SITE INSPECTION SHEET

OWNER: MONEY, JEFFREY X JR PHONE #: _____
ADDRESS: 3299 SADDLE HORSE CRT CONTRACTOR: _____
GLENWOOD MD 21338 WELL TAG #: NO TAG
SUBDIVISION: GLENWOOD 1ST LOT: 2 COUNTY #: XIII
PROPOSAL: BP 21003882 - NEW AGLPT 1-1209

SURVEY OF
LOT 2
SECTION TWO
GLENWOOD ESTATES
RECORDED AS PLAT # 3500
3288 SADDLE HORSE COURT
4TH ELECTION DISTRICT, HOWARD CO., MD
TAX MAP: 21, GRN: 6, PARCEL: 181

LOCATION DIAGRAM

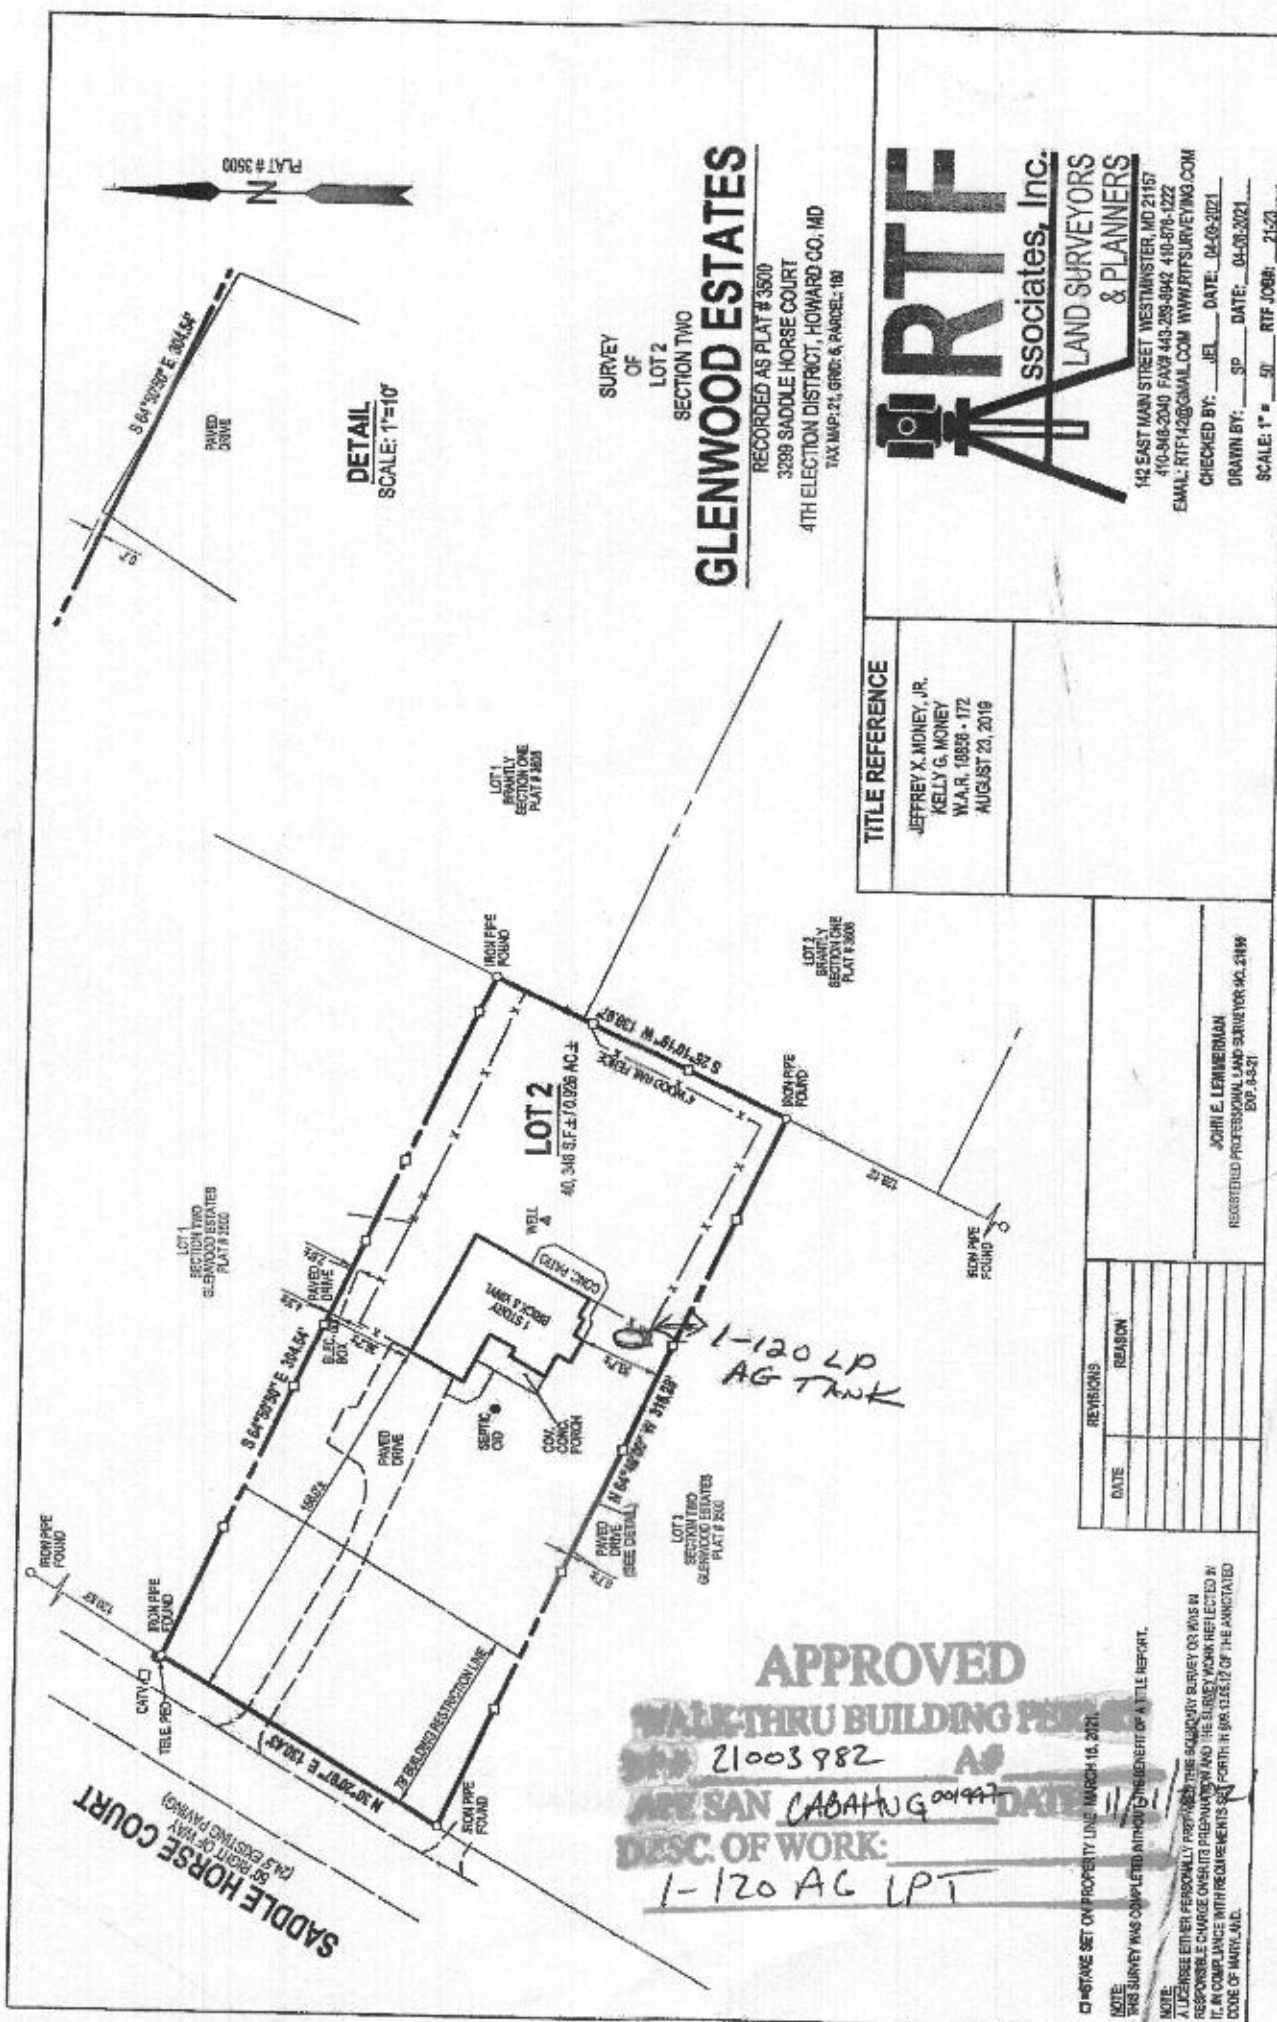
COMMENTS: ABOVE GROUND PROP. TANK
TO WELL 10'
TO SDA 5'
TO SEPTANK 5'
